SUBJECT: FERMI 2 - ISSUANCE OF AMENDMENT RE: THERMAL-HYDRAULIC STABILITY, IDLE RECIRCULATION LOOP STARTUP, AND POST-ACCIDENT MONITORING (TAC NO. MA0721)

AMENDMENT NO. 128 TO FACILITY OPERATING LICENSE NO. NPF-43 - FERMI 2

SAFETY EVALUATION BY THE OFFICE OF NUCLEAR REACTOR REGULATION

FIGURE 3.4.10-1

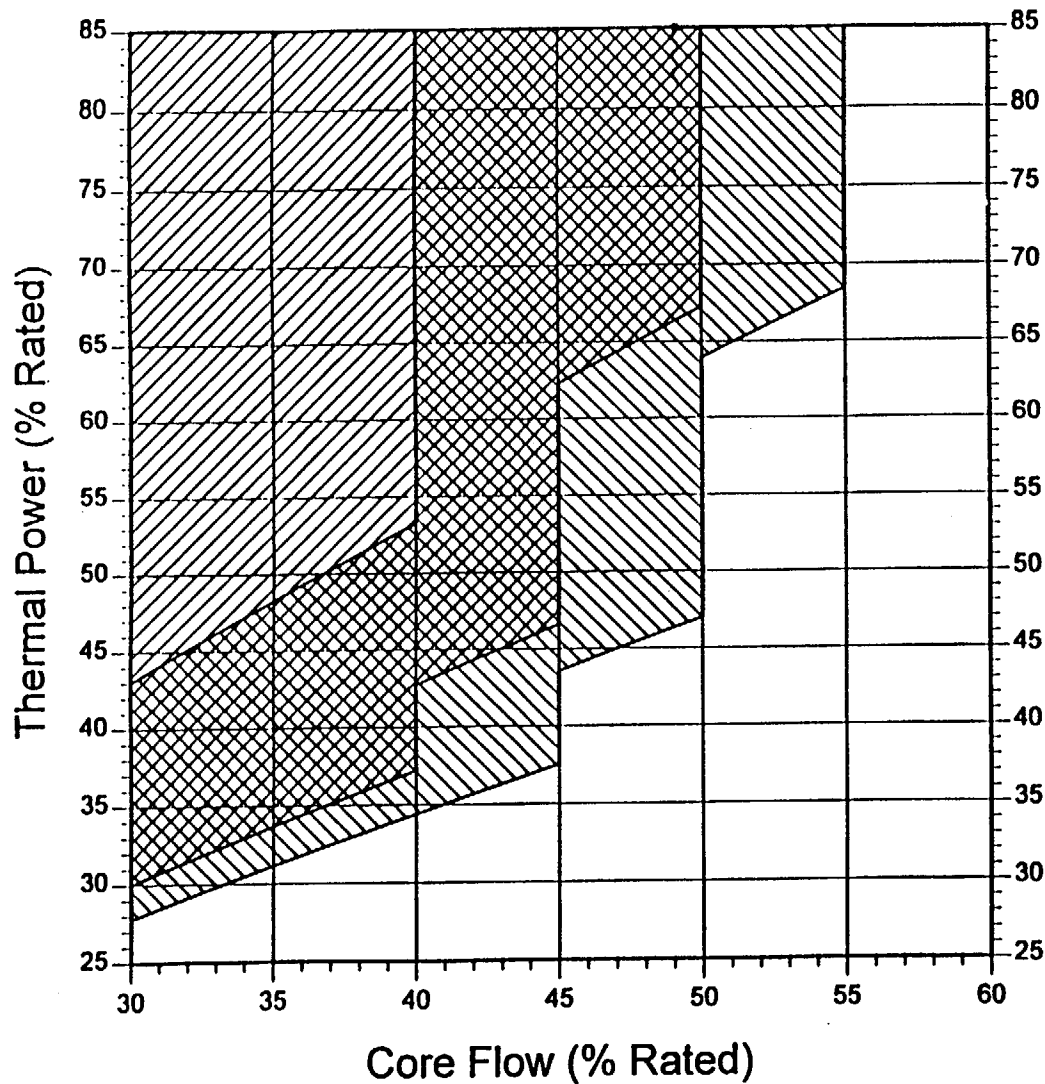
The amendment revises TS 3.4.10, TS Figure 3.4.10-1, and the associated bases by changing the prohibited and restricted operating region associated with core thermal-hydraulic stability. Also, TS 3.4.1.4, TS Figure 3.4.1.4-1, and the associated bases are revised to reflect stability-related improvements in operating restrictions for idle recirculation loop startup. Finally, in an unrelated change, TS Tables 3.3.7.5-1 and 4.3.7.5-1 are revised to delete neutron flux from the list of accident monitoring instrumentation in TS 3.3.7.5.

##### 3.1.2 Changes to Figure 3.4.10-1, Thermal Power Versus Core Flow

TS Figure 3.4.10-1 is being updated to be consistent with the BWROG guidance on stability interim corrective actions as stated in BWROG letter BWROG-94079. The licensee committed to implement this guidance in its response to GL 94-02. Using the proposed new terminology, the Scram Region boundaries remain the same. But, the Exit Region boundaries are larger, providing additional stability margin. The new figure also includes a Stability Awareness Region. This change is consistent with the current BWROG guidance that has been reviewed by the staff and is, therefore, acceptable.

Action 3.4.10.a      This action statement is updated to be consistent with the nomenclature of the revised Figure 3.4.10-1.

SR 4.4.10.2 is replaced to indicate that while operating in the stability awareness region indicated on the revised Figure 3.4.10-1 the APRM and LPRM signals should be checked at least once every hour to confirm that the reactor is stable.

- 
**Scram Region:**  
 >96% Rod Line, <40% Core Flow

- 
**Exit Region:**  
 Not in Scram Region  
 - and -  
 >67% Rod Line, <40% Core Flow  
 >77% Rod Line, <45% Core Flow  
 >103% Rod Line, <50% Core Flow

- 
**Stability Awareness Region:**  
 Not in Scram or Exit Regions  
 - and -  
 >62% Rod Line, <45% Core Flow  
 >72% Rod Line, <50% Core Flow  
 >98% Rod Line, <55% Core Flow
